KANSAS GAS AND ELECTRIC COMPANY

KMLNRC 82-252

Re: Docket No. STN 50-482

Subj: Potential 10CFR50.55(e) Report - Restricted
Movement of Nonstationary Pipe Supports

SECTION A-A

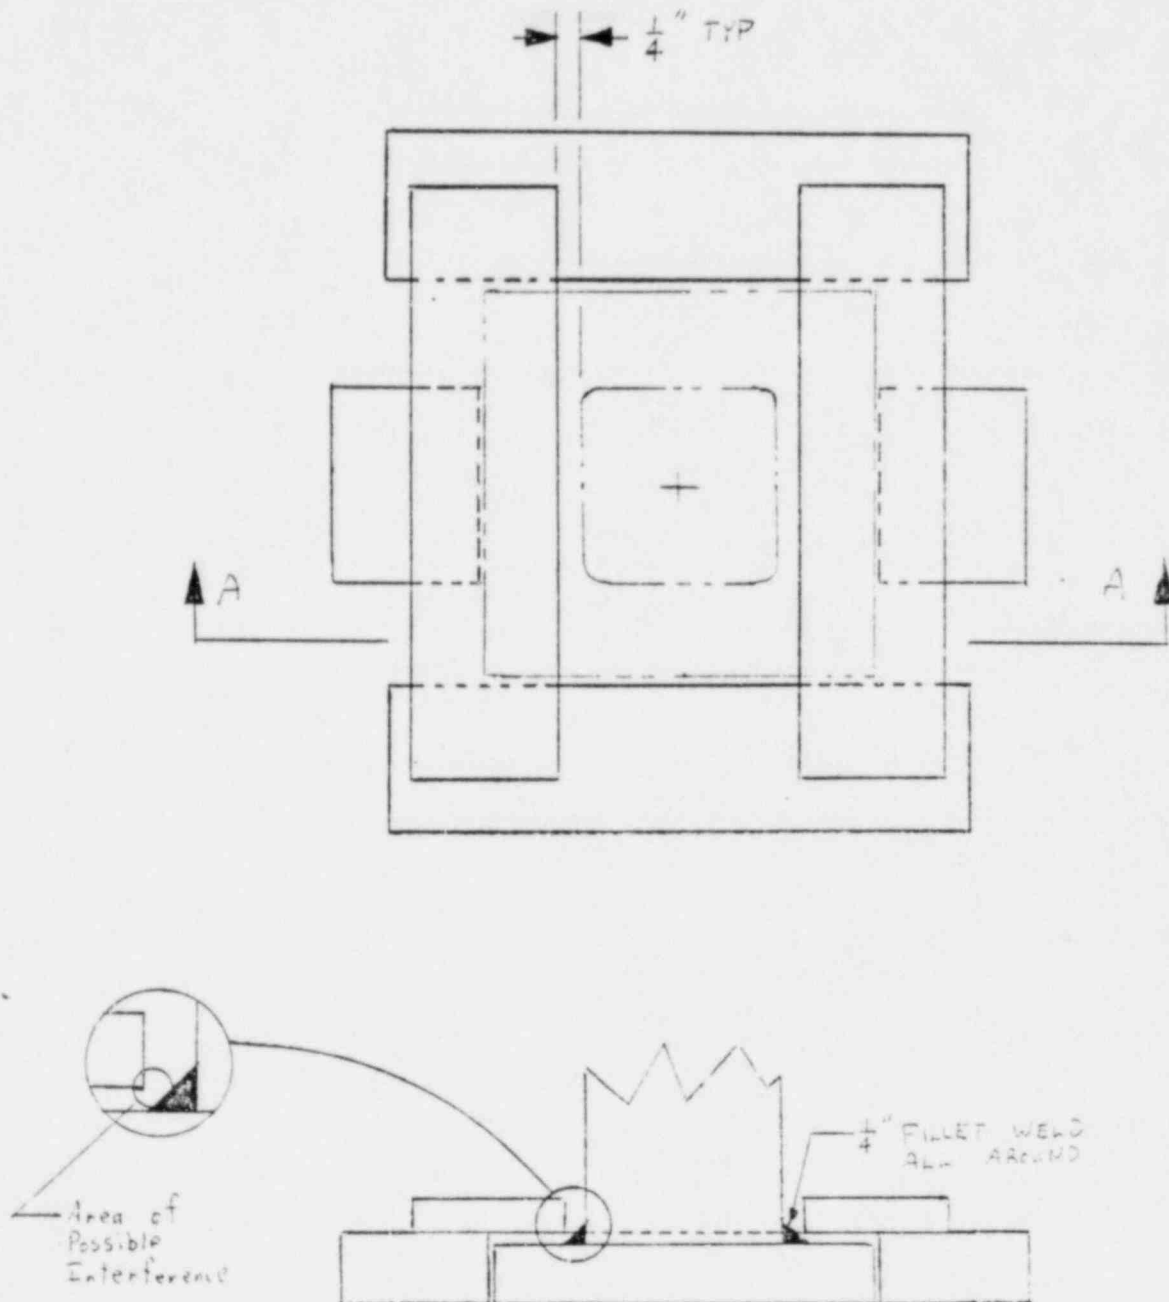
The pipe support in question is used in small pipe applications, including some safety-related systems. Attachment 1 shows a sketch of the support in question. The support is designed to allow approximately 1/16 inch of movement in two directions and 1/8 inch in the third direction. Movement can be restricted due to the weld crown size of the ASME Code acceptable stanchion fillet weld.

During a recent inspection, it was discovered that several supports had restricted movement due to interference between the stanchion fillet weld and the stationary base assembly. Further investigation revealed 608 installed supports with restricted movement. Nonconformance Report 1SN4927PW was initiated to document the discrepancy and track its resolution.

SECTION A-A

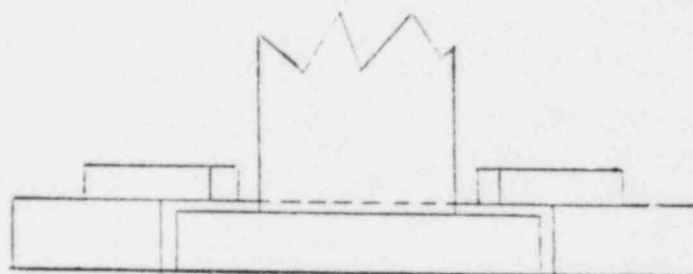
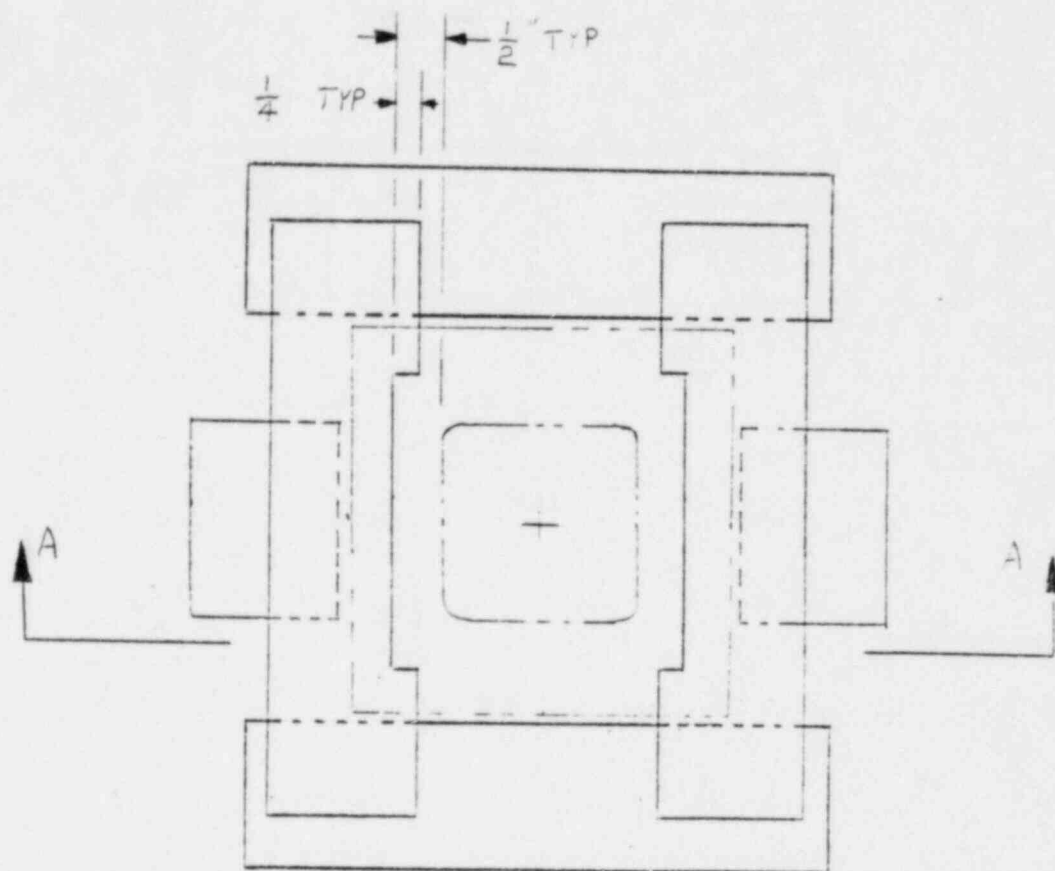
The A/E is in the process of evaluating each of the 608 supports to determine whether or not any of these supports require full movement. None of the supports evaluated so far have required any such movement. To eliminate this concern in the future and to aid in the ease of installation, the A/E had modified the design for future supports as illustrated in Attachment 2.
